Re: Indian Point Unit No. 2
Docket No. 50-247
NL-04-073

SUBJECT: **Reply to Request for Additional Information Regarding
Indian Point 2 Stretch Power Uprate (TAC MC1865)**

**REPLY TO NRC REQUEST FOR ADDITIONAL INFORMATION REGARDING
PROPOSED LICENSE AMENDMENT REQUEST FOR
INDIAN POINT 2 STRETCH POWER UPRATE**

Figure PVM-5
Probability of Correct Rejection
Sizing, Std. Dev. = 0.12, Acceptable Flaw Size 0.15

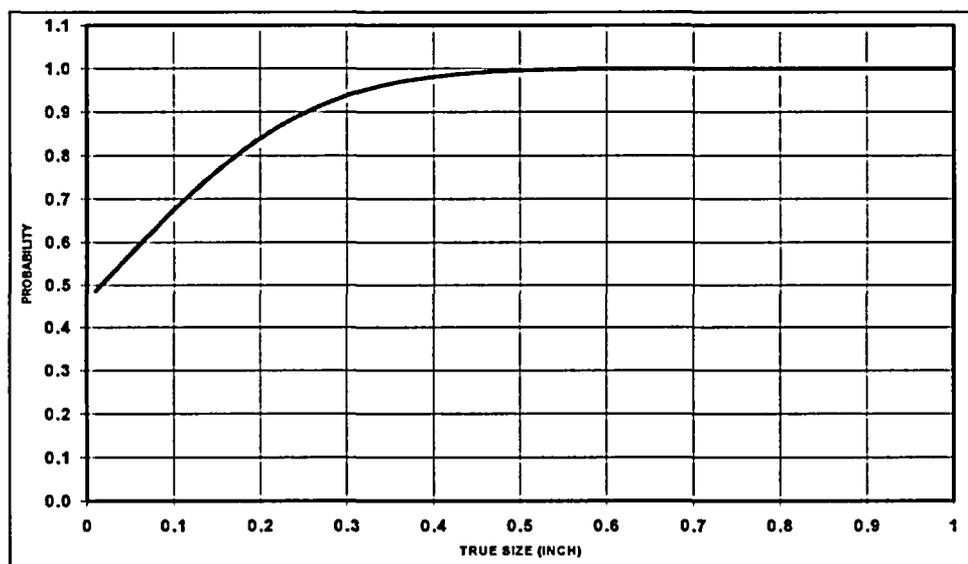
- a. Identify the references for the report that justifies the use of a 1/5 T defect for the outlet nozzle to shell weld. Identify whether the analysis satisfies the requirements of Article G-2220 of Section XI of the ASME Code.
- b. Describe the non-destructive inspection technique which will be utilized to examine the nozzle inner radius at the outlet nozzle to shell region.
- c. Provide the data and describe the analysis that the probability of detecting a flaw with a depth of 0.5-inch is greater than 99.9%.

Figure PVM-5 depicts the expected rejection probability as a function of flaw size. Correct rejection probability considers the detection capability and the sizing capability for flaws. For example, as shown in Figure PVM-5, the probability of detecting and rejecting a flaw 0.25 inch into the base material is equal to or greater than 90%.

**Figure PVM-2-9:
Probability of Correct Rejection/Reporting (PCR) Considering Only Passed Candidates,
Appendix VIII from the Outside Surface. Reporting Criterion $A' = 0.15$ inch.]**

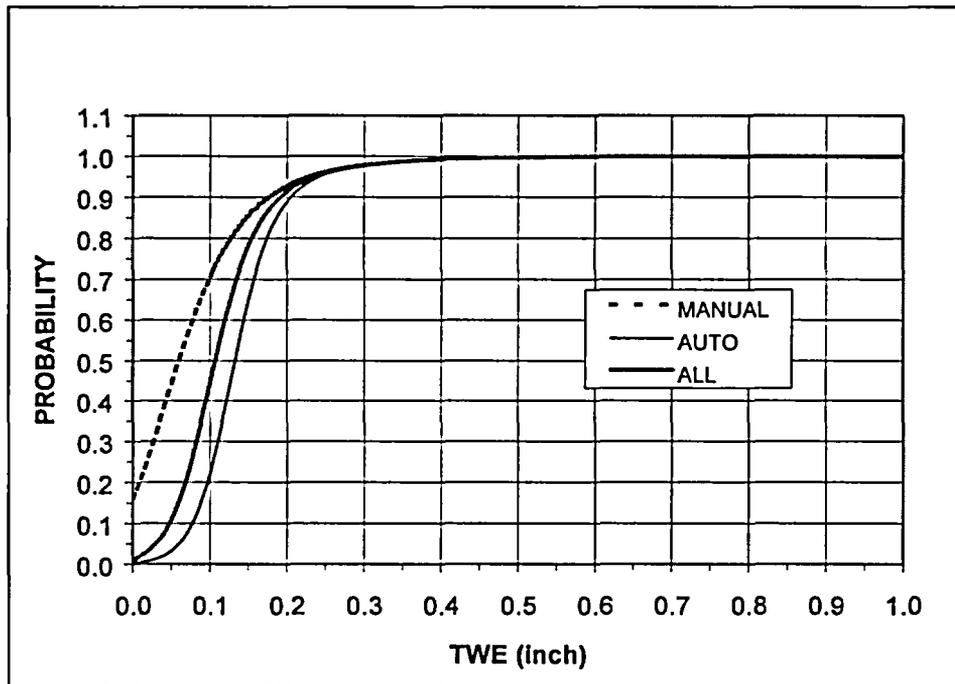
- Describe the analysis that determined a 0.50-inch flaw depth for the safety and relief nozzle (corner) and a 0.15-inch flaw depth for the upper shell will meet the fracture toughness requirements of Appendix G of the ASME Code.
- Identify whether the analysis satisfies the requirements of Article G-2220 of Section XI of the ASME Code. Does the analysis for the safety and relief nozzles and upper shell satisfy these structural factors?
- Describe the non-destructive examination technique which will be utilized to inspect the safety and relief nozzles and upper shell.
- Provide the data, a description of the analysis, and the probability of detection of flaws with a depth of 0.50-inch for the safety and relief nozzle and 0.15-inch for the upper shell.

The PODs for the safety and relief nozzle and the upper shell are taken from EPRI Report, "Justification for the Reduction of Inspection Requirements for the Boiling Water Reactor Nozzle-to-Vessel Shell Welds And Nozzle Blend Radii (VIP-108)", R. Carter, June 2002. This report is deemed applicable as the shell thickness and nozzle diameters are similar. As shown in the following figure the PODs of flaws with a depth of 0.50-inch for the safety and relief nozzle and 0.15-inch for the upper shell are 99.9% and 85%, respectively.
